Merged Document Report

Application No.: PL9193

PLAT OF CABANISS ACRES BLOCK 8, LOTS 7AB & 7AC

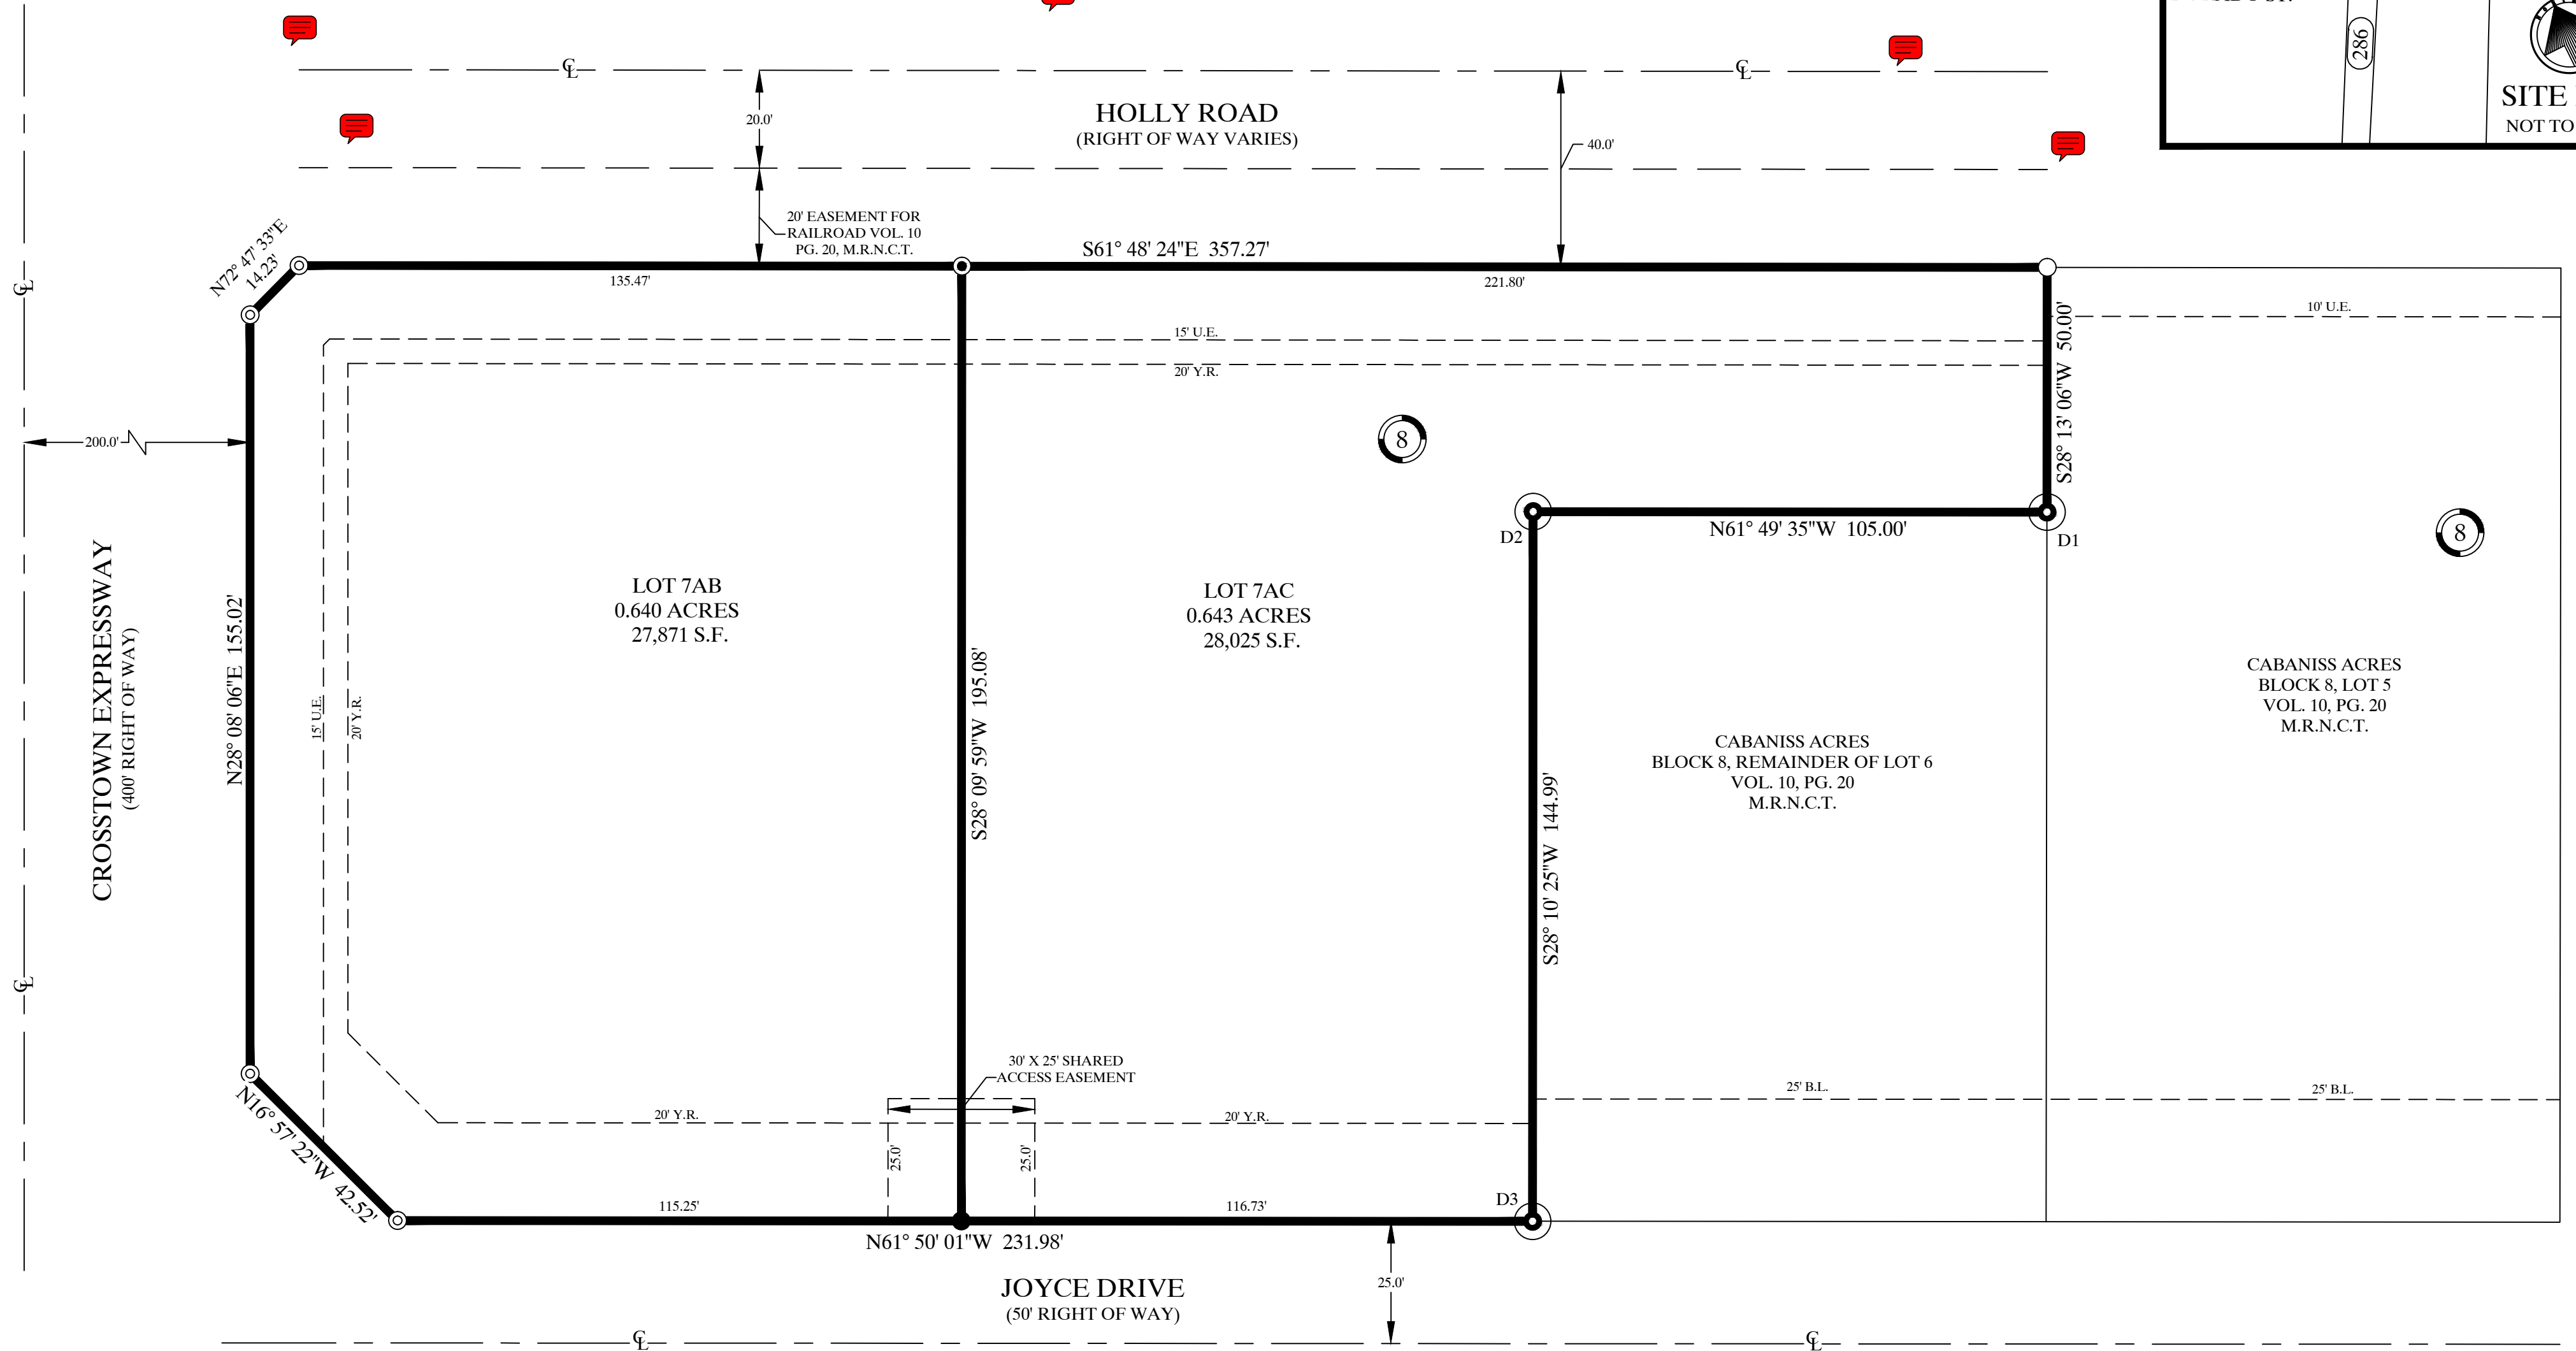
Comment ID	Page Reference	Annotation Type	Author : Department	Status	Review Comments	Applicant Response Comments
3	P002	Note	Mina Trinidad : DS	Closed	(Informational) CCRTA: This plat is not located along any existing or planned CCRTA bus service routes.	
4	P002	Note	Mina Trinidad : DS	Closed	(Informational) AEP Transmission has no comment.	
5	P002	Note	Mina Trinidad : DS	Closed	(Informational) GIS: Plat closes within acceptable engineering standards.	
6	P002	Note	Mina Trinidad : DS	Closed	Fire: (Chief Juan Perez)

Comment ID	Page Reference	Annotation Type	Author : Department	Status	Review Comments	Applicant Response Comments
					<p>All code reference is based on currently adopted International Fire Code (IFC) 2021 and Corpus Christi Water Distribution Standards</p> <p>Plat: 503.2.1 Dimensions. Fire apparatus access roads shall have an unobstructed width of not less than 20 feet, exclusive of shoulders and an unobstructed vertical clearance of not less than 13 feet 6 inches.</p> <p>503.4 Obstruction of fire apparatus access roads. Fire apparatus access roads shall not be obstructed in any manner, including the parking of vehicles. The minimum widths and clearances established in sections D103 shall always be maintained.</p> <p>503.3 Marking: Where required by the fire code official, approved signs, or other approved notices the include the words NO PARKING-FIRE LANE shall be provided for fire apparatus access roads to identify such roads to prohibit the obstruction thereof. The designation of a fire lane can be marked with conspicuous signs which have the words: " Fire Lane-No Parking" at 50-foot intervals. In lieu of signs, fire lanes may be marked along curbing with the wording, "Fire Lane-No Parking" at 15-foot intervals.</p> <p>Table D103.4 Requirements for Dead-end fire apparatus access roads. Turnaround provisions shall be provided with a 96-foot diameter cul-de-sac. (Hammerhead designs will no longer be accepted due to the hazards created by backing emergency vehciles.)</p> <p>503.2.5 Dead ends. Dead-end fire apparatus access roads more than 150 feet in length shall be provided with an approved area for turning around fire apparatus.</p> <p>Information: 503.1.1 (amendment) Buildings and facilities: Approved fire apparatus access roads shall be provided for every facility, building, or portion of a building hereafter constructed or moved into or within the jurisdiction. The fire apparatus access road shall allow access to three (3) sides of buildings in excess of fifteen thousand (15,000) square feet and all sides for buildings in excess of thirty thousand (30,000) square feet. During construction, when combustibles are brought on to the site in such quantities as deemed hazardous</p>

Comment ID	Page Reference	Annotation Type	Author : Department	Status	Review Comments	Applicant Response Comments
					<p>by the fire official, access roads and a suitable temporary supply of water acceptable the fire department shall be provided and maintained.</p> <p>Gates: D103.5 Fire apparatus access road gates. Gates securing the fire apparatus access roads shall comply with all the following criteria: Single gate width shall not be less than 20 feet. 12 feet gate width is required for a divided roadway. Electric gates shall be equipped with a means of opening the gate by fire department personnel for emergency access. Emergency opening devices shall be approved by the fire code official. Note: The use of a Knox Gate Switch is currently required by the Fire Official. Methods of locking shall be submitted for approval by the fire code official. Note: The Knox Padlock is currently required by the Fire Official. Electric gate operators, where provided, shall be listed in accordance with UL 325. Gates intended for automatic operation shall be designed, constructed, and installed to comply with the requirements of ASTM F 2200.</p>

7	P002	Note	Mina Trinidad : DS	Closed	(Informational) Parks and Recreation Department: No fees due as there are no newly proposed residential dwelling units to be constructed. Purpose of this plat is, "To have each building and parking on a platted lot." As such no fees are to be applied.	
8	P002	Note	Mina Trinidad : DS	Closed	<p>(Informational) CCW: Water Water construction is not required for platting (UDC 1.2.1.D & 8.2.6; Water Distribution Standards).</p> <p>Wastewater Wastewater construction is not required for platting (UDC 1.2.1.D & 8.2.7; Wastewater Collection System Standards).</p>	
9	P002	Note	Mina Trinidad : DS	Closed	(Informational) TxDOT: Note #8 of the plat already states, "No access to State Highway 286 Frontage." No other comments.	
10	P002	Note	Mina Trinidad : DS	Closed	Add plat note: Access rights to parking areas and driveways are hereby granted to all adjoining commercial properties.

11	P002	Note	Mina Trinidad : DS	Closed	(Informational) Equistar Pipeline will not be involved, no comment.	
12	P002	Note	Mina Trinidad : DS	Closed	PLAT – ROADWAY MASTER PLAN • The proposed plat does not impact or alter the existing Transportation Master Plan.

Comment ID	Page Reference	Annotation Type	Author : Department	Status	Review Comments	Applicant Response Comments
					<p>PLAT – TRAFFIC – PEAK HOUR TRAFFIC / TIA:</p> <ul style="list-style-type: none"> • Peak Hour Traffic (PHT) form DOES NOT show an excess of 500 trips for both the AM peak trips times & the PM peak trip times. A Traffic Impact Analysis (TIA) will NOT be required. <p>PLAT – COMMENT: (CITY ACCESS MANAGEMENT / ROW)</p> <ul style="list-style-type: none"> • Proposed driveway details & dimensions required for review and approval from Public Works Traffic / ROW. • Location of proposed driveway will require review and approval from Public Works Traffic / ROW – this is separate from the building permit from Development services Department. Typically, this approval should be done before the issuance or approval of a building permit. • Proposed Driveway access to public City Street shall conform to access management standards outlined in Article 7 of the UDC (UDC 7.1.7) • A ROW Construction Permit, issued by PW-Traffic Department (Right-of-Way Division), is required for any proposed driveway (construction entrance, temporary or permanent), work obstructing, closing, or occupying public right-of-way (Reference Chapter 49-2). <ul style="list-style-type: none"> o The ROW Construction permit must be submitted and approved prior to any form of construction within City ROW. o The developer / applicant can reach out to rowmanagement@corpuschristitx.gov for further assistance regarding the ROW Construction Permit they will be required to submit prior to any temporary and / or permanent driveway off the immediate roadways. o Any contractor working within City ROW without an approved ROW Construction Permit can be held in non-compliance and can be subject to a fee of \$1,500 per day of unpermitted work, as per City of Corpus Christi Municipal Code 49-112 (9). • The PW-Traffic Department (Right-of-Way Division) is responsible for reviewing and permitting new construction and repairs/modifications to driveways, sidewalks, curb, and gutter or any work within utility easements. o All work shall be performed in accordance with the city's construction standards. A permit shall not be issued for any tract or property where a final plat is required to obtain a building permit. (Refer to Muni-code Chapter 49-30 for permit requirements.) <p>(TXDOT ACCESS MANAGEMENT / ROW) For any driveway (access management), blockage, or encroachment on or within the TXDOT's ROW</p>

Comment ID	Page Reference	Annotation Type	Author : Department	Status	Review Comments	Applicant Response Comments
					<p>please see below:</p> <ul style="list-style-type: none"> • The developer / applicant can reach out to TXDOT for further assistance regarding the construction in their ROW. o Eric Martinez (TXDOT - Area Engineer for CC) - Eric Martinez eric.martinez@txdot.gov • TXDOT ROW process is the RULIS program (utility tie-ins) o David Brink (TXDOT- RULIS) - David Brink david.brink@txdot.gov o Right of Way Utility and Leasing Information System 	
2	Utility	Note	Bria Whitmire : DS	Closed	Indicate separate water meters and yard lines. Confirm water services are separated.	
1	P002	Note	Bria Whitmire : ENG	Closed	<p>Improvements Required for Recordation, per UDC 8.1.4.</p> <ul style="list-style-type: none"> A. Streets: no Sidewalks: no B. Water: no Fire hydrants: no C. Wastewater: no D. Stormwater: no E. Public open space: no (UDC 8.3) F. Permanent monument markers: no <p>Please note, improvements required should be constructed to city standards, found in Article 8 and the IDM.</p>
